To:	Isobella Wise	From:	Drainage (Cecily Austin)
------------	---------------	--------------	--------------------------

Planning App Ref:	PL/2026/04916
Service Ref:	Drainage
Date:	01/10/2026

Outline application for up to 225 dwellings, with access from Semington Road, along with public open space and landscape buffers to incorporate existing rights of way and to accommodate the route of the proposed Melksham Link Canal (under separate application W/12/01080/FUL). Demolition and clearance of all existing buildings and structures on the site. All matters reserved other than vehicular access from Semington Road.

Land west of Semington Road, Melksham

Figure 2.6: The Intersection of the Proposed Canal Route with the Application Site (red line)

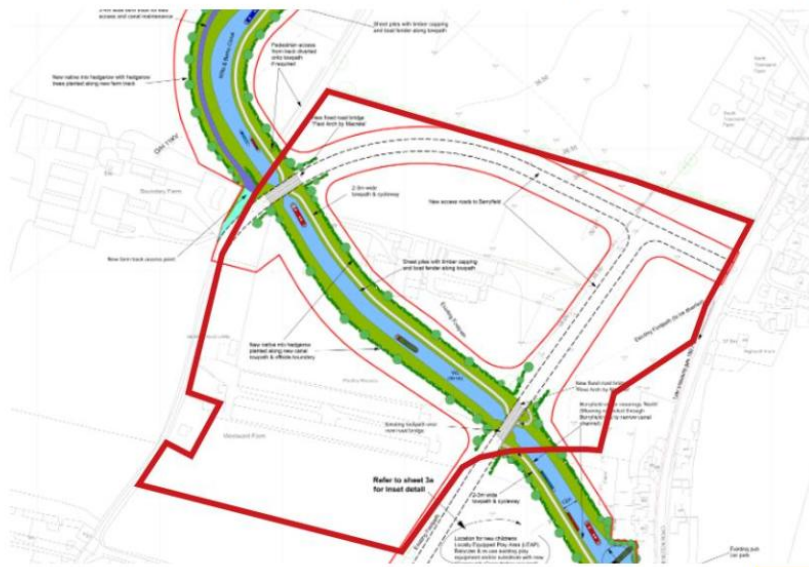
It is noted that proposals exist for a new canal running through the centre of the site, which was approved by the LLFA in August 2025 under application reference W/12/01080/FUL. Whilst this proposal is briefly referenced within the FRA and SuDS Statement, insufficient consideration has been given to its interaction with the proposed drainage strategy. The plans indicate that several SuDS features have been located within the corridor identified for the canal. This raises issues regarding the feasibility of the proposed drainage design, as SuDS features are positioned within the canal area – please see screenshots below. On this basis, the LLFA requests a holding objection on this application as current proposals are mutually exclusive.

The applicant should provide an overlay of the approved canal alignment and the proposed drainage layout to demonstrate compatibility between the two schemes. The drainage strategy should then be revised as necessary to accommodate the canal infrastructure. Furthermore, the FRA should assess the canal proposals and consider any implications for flood risk, including the identification of appropriate mitigation measures where required.

- Further investigation into the approved canal proposals. The applicant should assess how the canal may affect flood risk both review the proposed drainage strategy. An overlay should be provided showing the relationship between the canal alignment and the proposed drainage infrastructure. The drainage design should then be revised where necessary to allow the canal
